Oak Street: 3rd Street to Grand Canal

Construction Field Change

Design Concept (Pre-Construction)

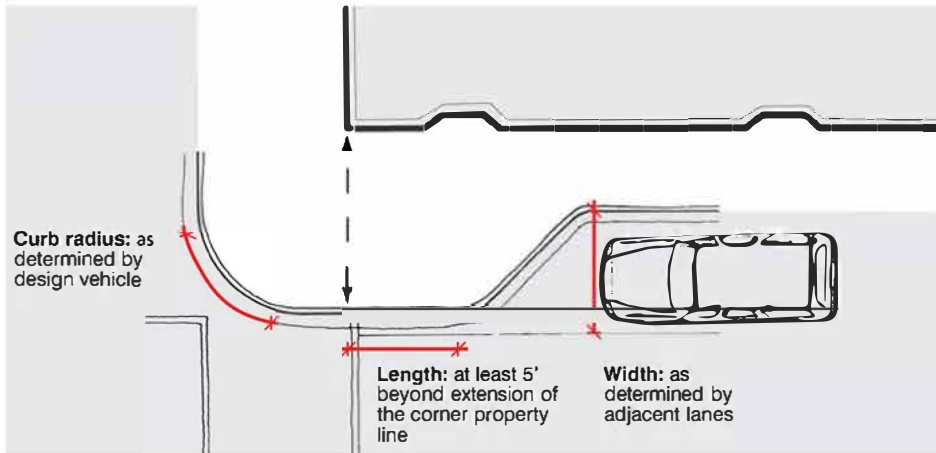
Conflict:

During construction it was discovered that the design concept would prevent proper drainage of storm water.

Differences between Design Concept and Actual:

- Travel distance for pedestrians not reduced

Resolution:

To avoid any issues with drainage, the design concept was modified to allow the passage of storm water between the sidewalk and the chicane / island.
